**Re: Ralston Avenue Planning Proposal  
Response to the NSW Rural Fire Service (RFS)**

## **Response to the NSW Rural Fire Service Correspondence September 2016**

TITLE  
**Figure 2 - Forest vegetation located on slopes >20 degrees**

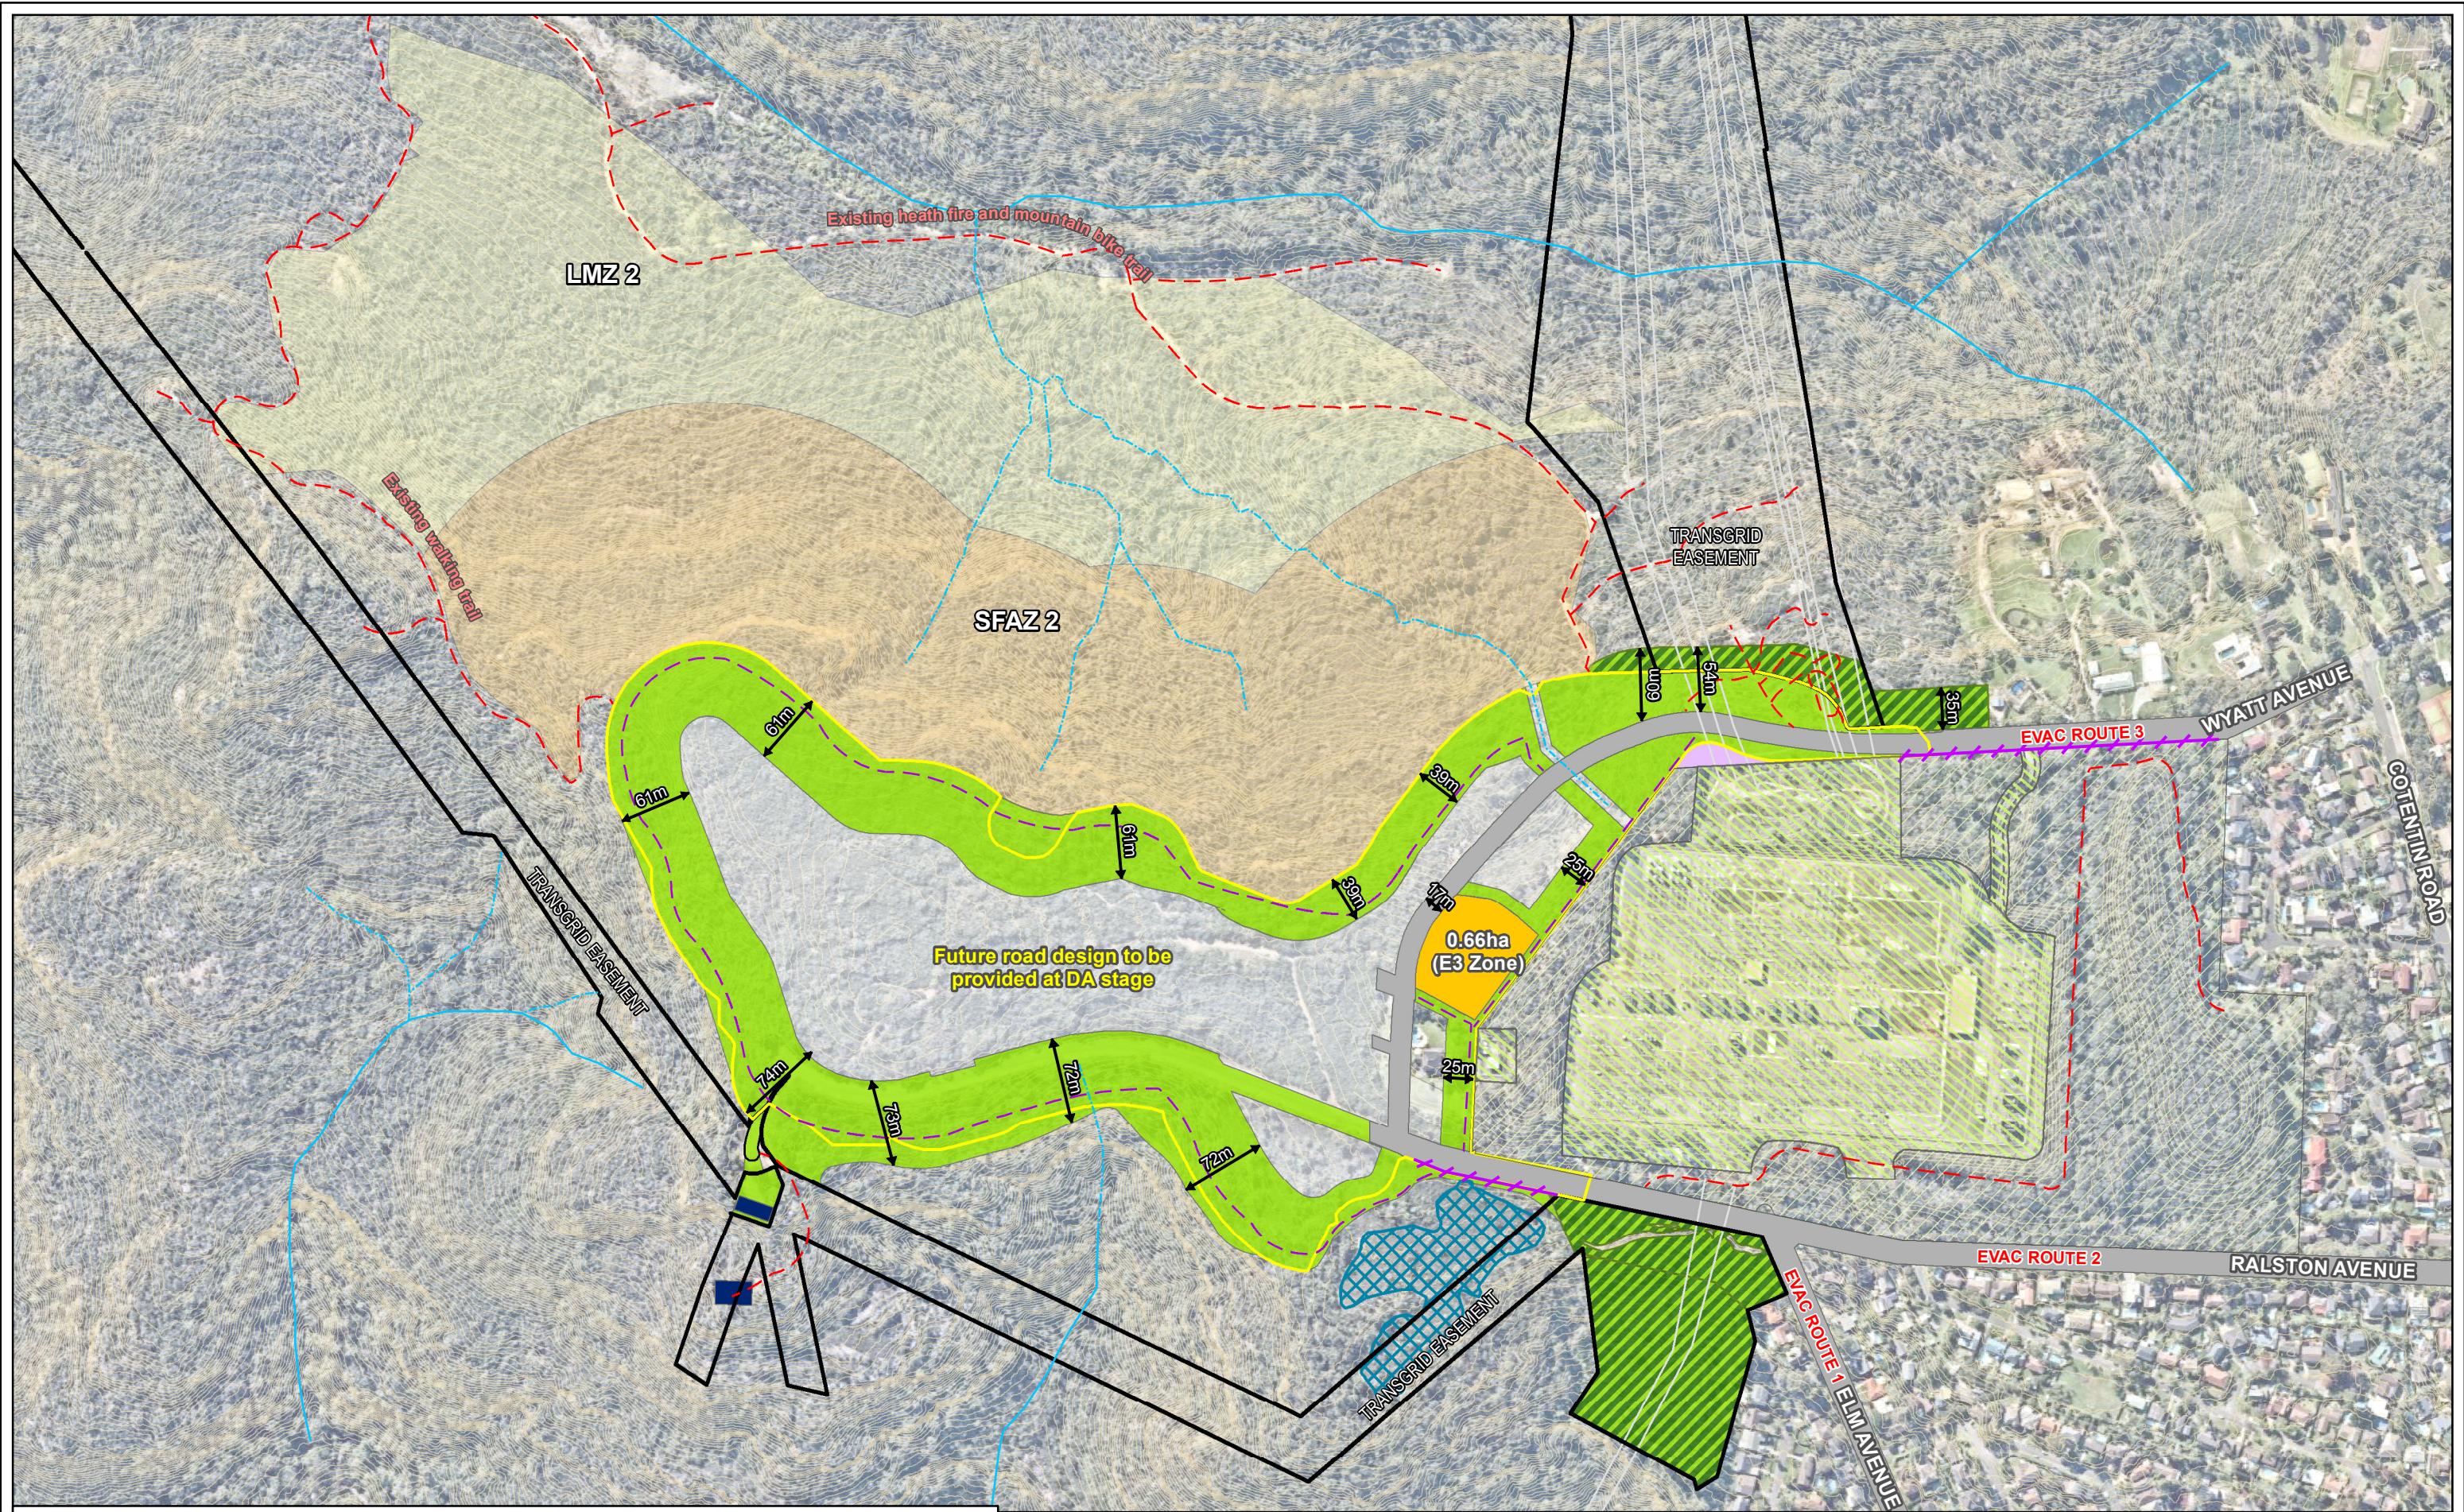
*The proposal will result in dwellings being located on the interface with slopes exceeding 20 degrees. Current building standards do not provide deemed to satisfy provision for determination of the maximum desired bushfire attack level (BAL 29) in these situations*

We also note the primary concern raised by the RFS was in relation to the slope gradient within the APZ and external to the APZ. We can advise these concerns are incorrect. Figure 2 shows the true extent of forested lands located on slopes >20 degrees.

AS3959 provides bushfire attack advice in respect of slopes up to 20 degrees. The extent of slopes exceeding 20 degrees is provided in Figure 2 above and do not predominate across the landscape. The fact that some areas are in excess of 20 degrees has in the past not been an impediment to the RFS approving developments.

**TITLE**  
**Figure 1 - Revisions to Planning Proposal (Bushfire)**

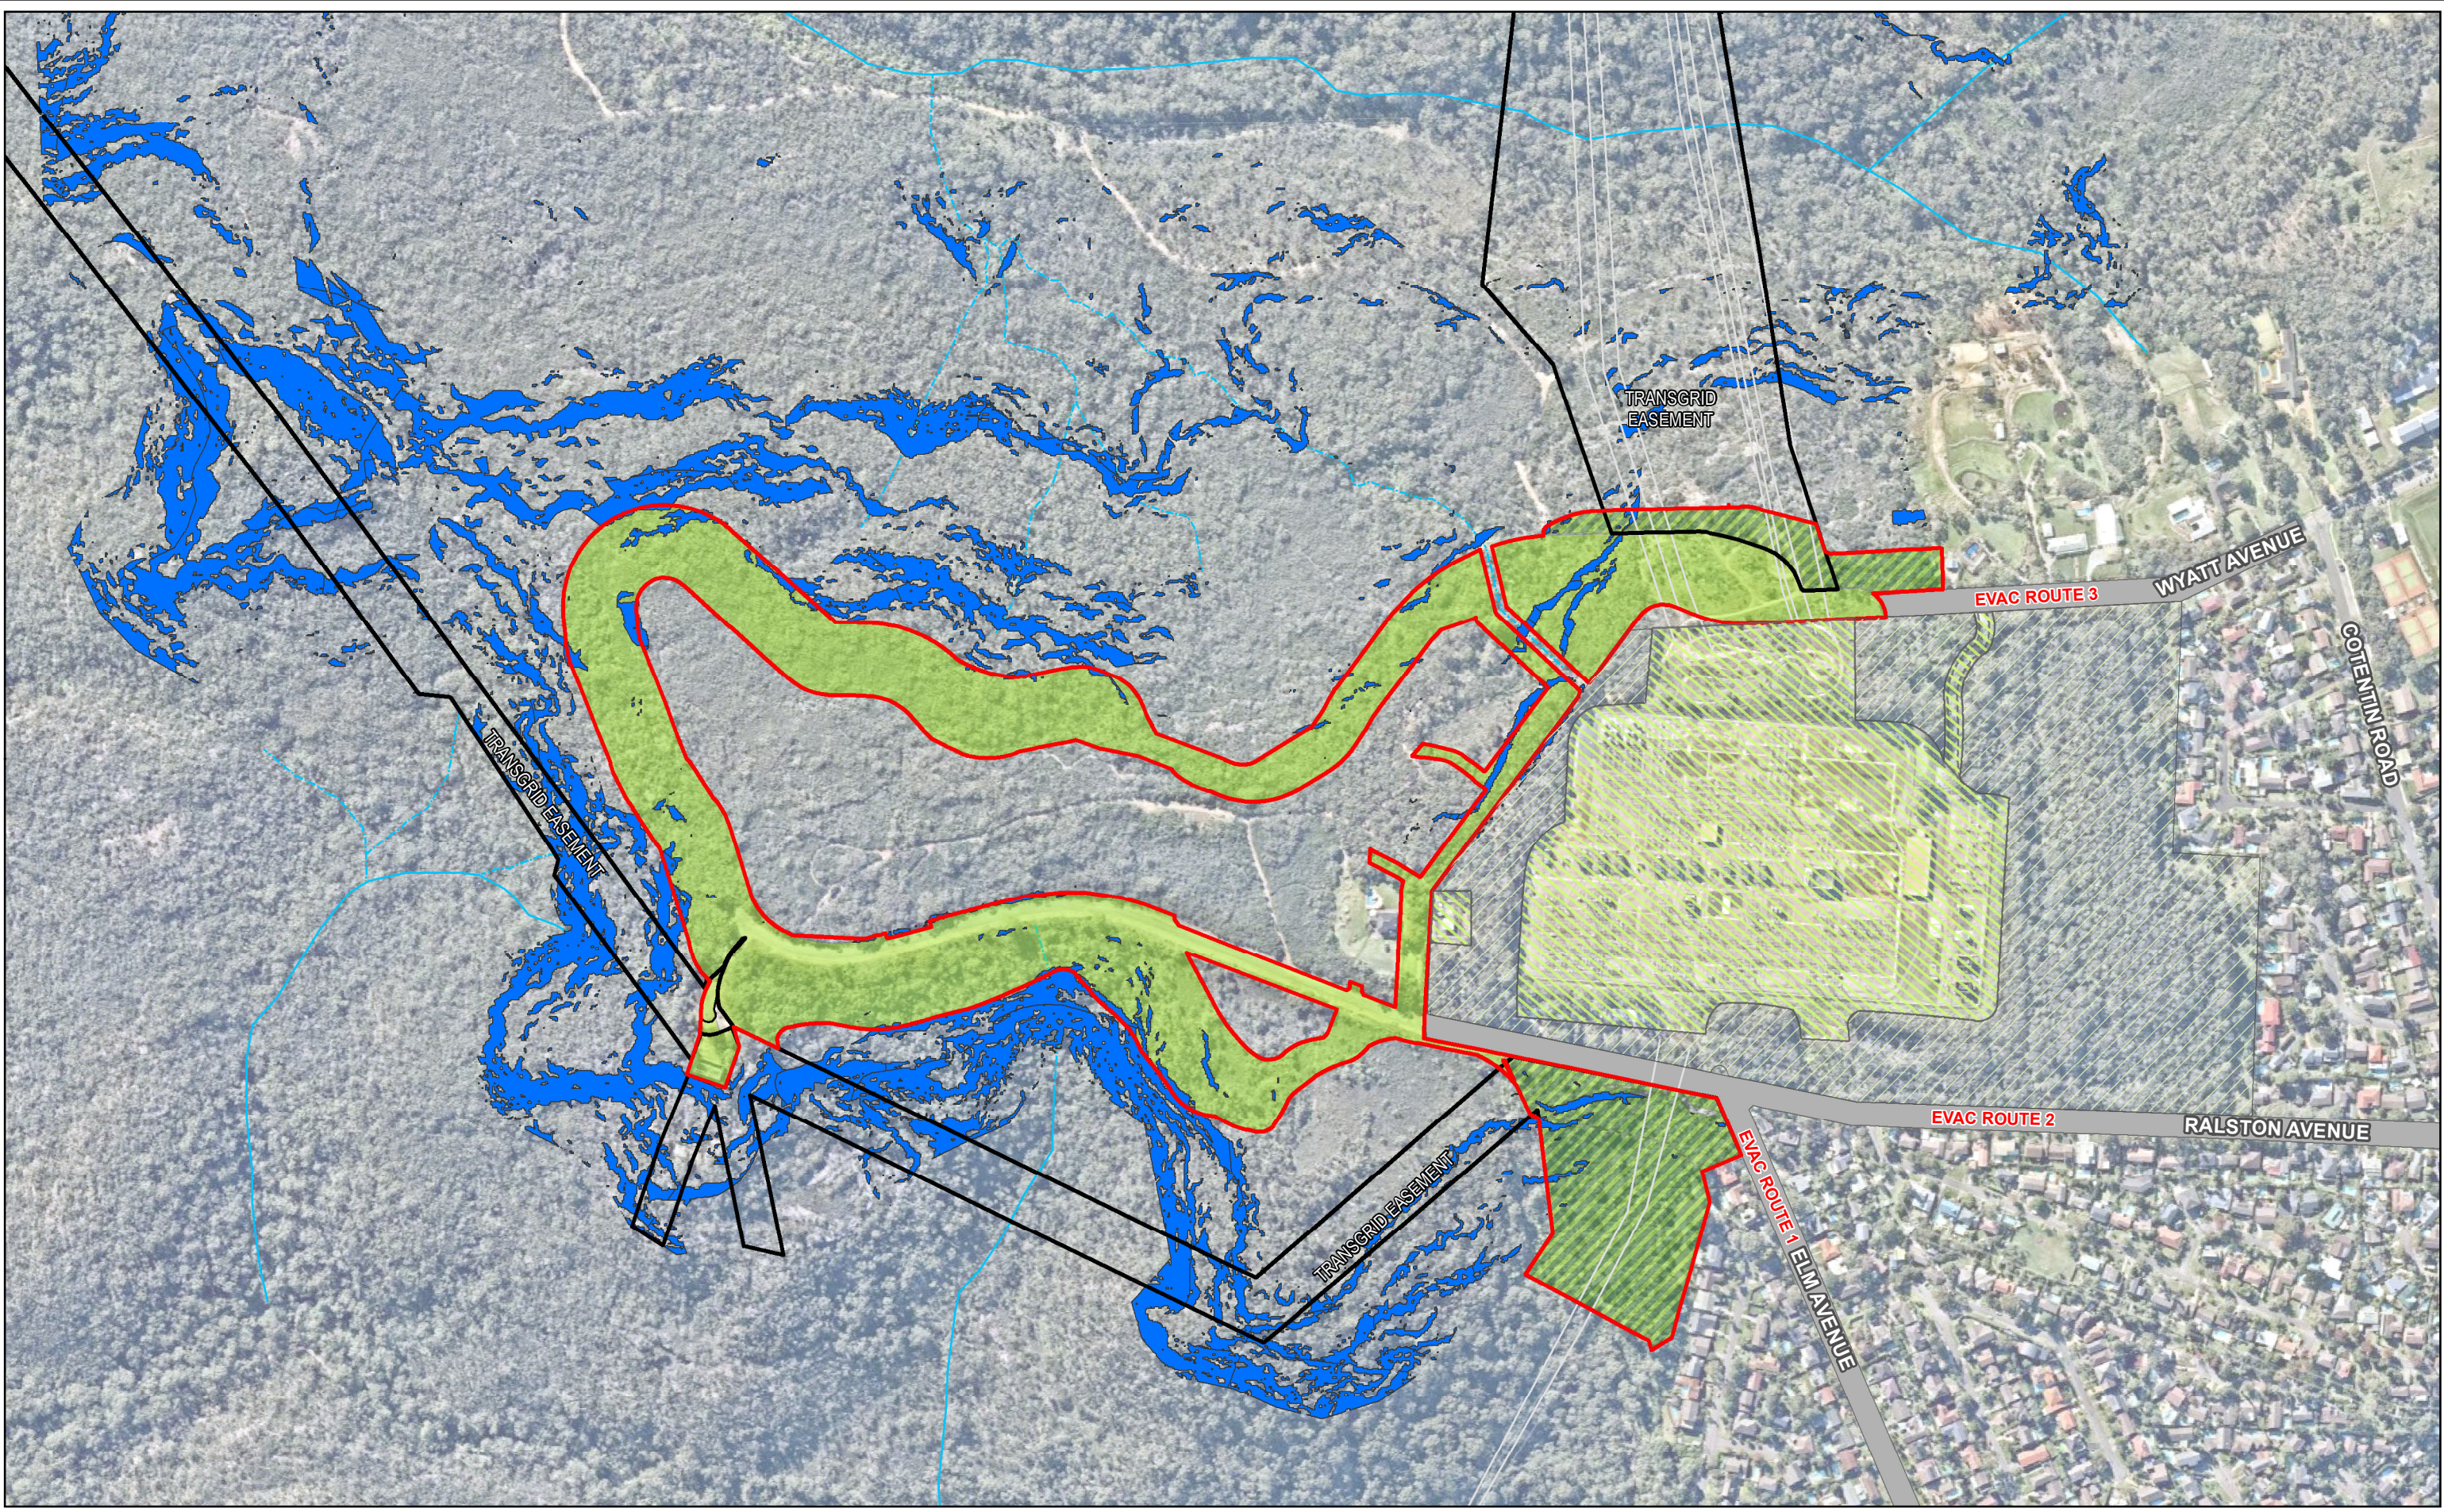
*Vehicular access to and from the site is problematic due to unmanaged vegetation along Ralston and Wyatt Avenues, with no measures proposed to ensure these evacuation routes remain accessible during a bush fire. The design and layout of the proposal also means that the perimeter road is likely to be cut off in several places during a bush fire, endangering both residents and emergency workers*

We can advise that the proposed development does comply with the Section 117 Direction, PBP 2006 and AS3959 '*Construction of bushfire prone areas*'. We do note some inconsistencies and amendments have been made to the bushfire protection measures and they are shown on Figure 1.

1. Increased APZ's reflecting smoother boundaries, increased depth on the southern aspect and the provision of APZ's on the TransGrid electrical easements lands adjacent to Ralston Avenue and Wyatt Avenue.
2. A reduction of the reserve (E3 Zone) has occurred (0.90ha to 0.66 ha). This is provided given the need to deny fire entering the site from the northwest aspect; and the need to impose a degree of common sense in respect of protecting the land owner's responsibilities (re; Section 63 of the Rural Fires Act) in respect of the TransGrid asset.
3. Improved road alignment in the north east to Wyatt Avenue.
4. Provision of several new fire trails in the vicinity of the TransGrid electrical facility and easement zones; and the landscape west of the Duffys Forest community.

Several areas located under electrical easements were not identified to contain APZs. These areas are already permitted to be cleared under the provisions of the electrical easement and therefore do not require rezoning and or approval through the Planning Proposal process.

To resolve any confusion these areas are now mapped as APZ's and resolve the pinch points noted by the RFS.

A plan is provided at Figure 1 illustrative of the changes.

**Figure 3** - Extract from Figure 4.1 of PBP on page 16

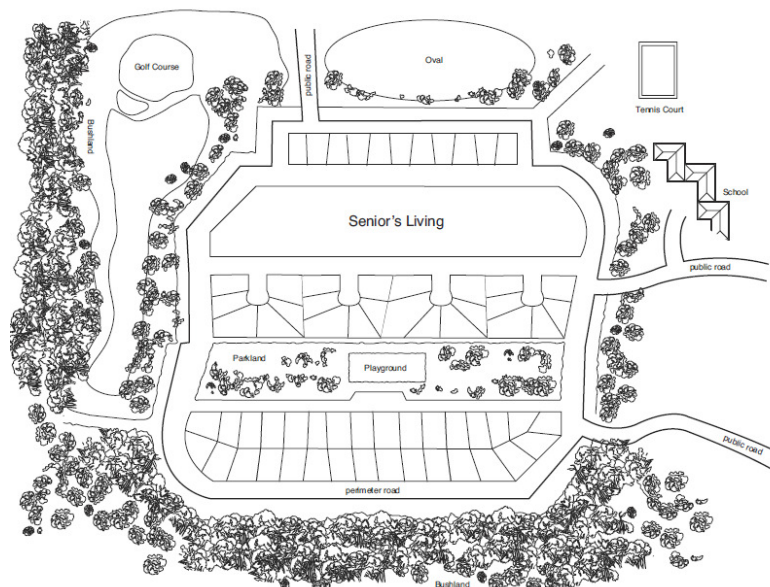
- (c) *contain provisions for two-way access roads which links to perimeter roads and/or to fire trail networks,*

Typically housing is located on the internal edge of the perimeter road but set back sufficiently to be complying with, or less than, BAL 29 AS3959. This is the typical design feature for residential estates and is replicated in Figure 3 below (Extract from Figure 4.1 of PBP on page 16). The figure depicts the perimeter on the bottom of the diagram and illustrates that flame will engulf the perimeter road.

**Figure 4** – Slopes analysis within the proposed APZ's

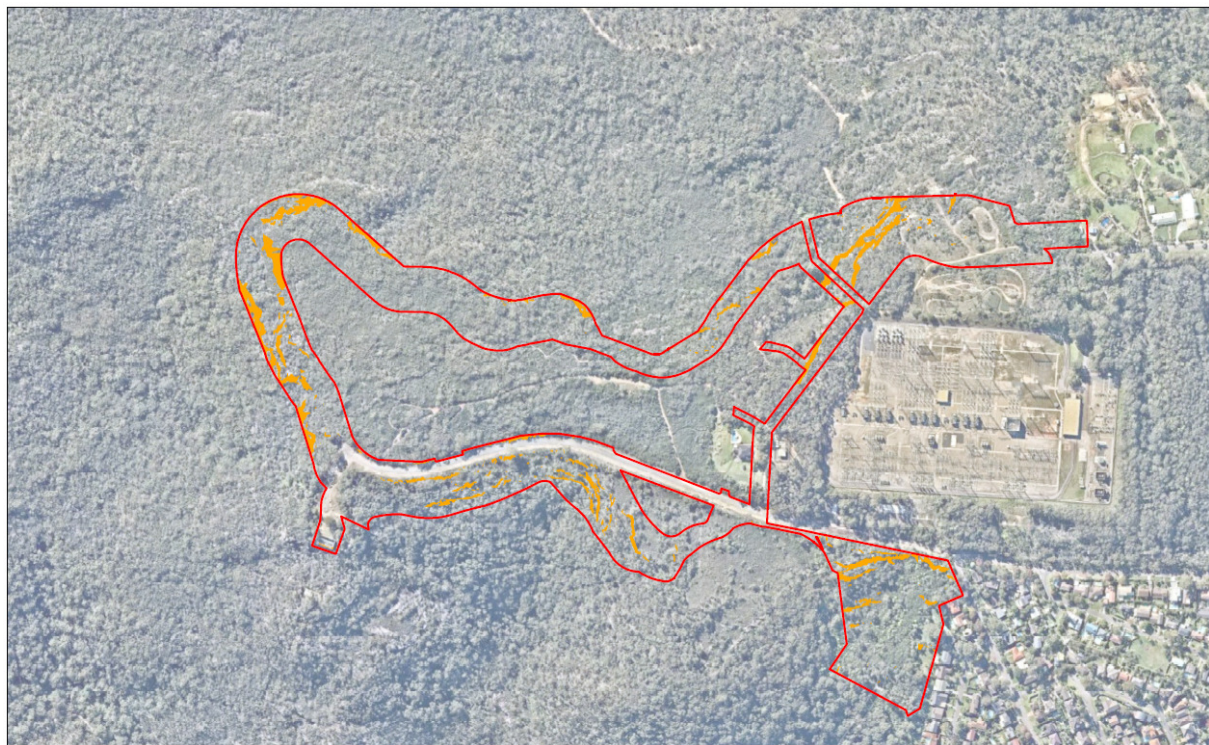
*The site has steep down slopes*

In addition, a site inspection occurred on 1 October 2015 with the RFS whereby the slopes occurring within the APZ were visually confirmed as being <18 degrees. Figure 4 below depicts the slopes within the APZ. Only a small area of 18 degree land is affected and these areas are sandstone rock shelves.
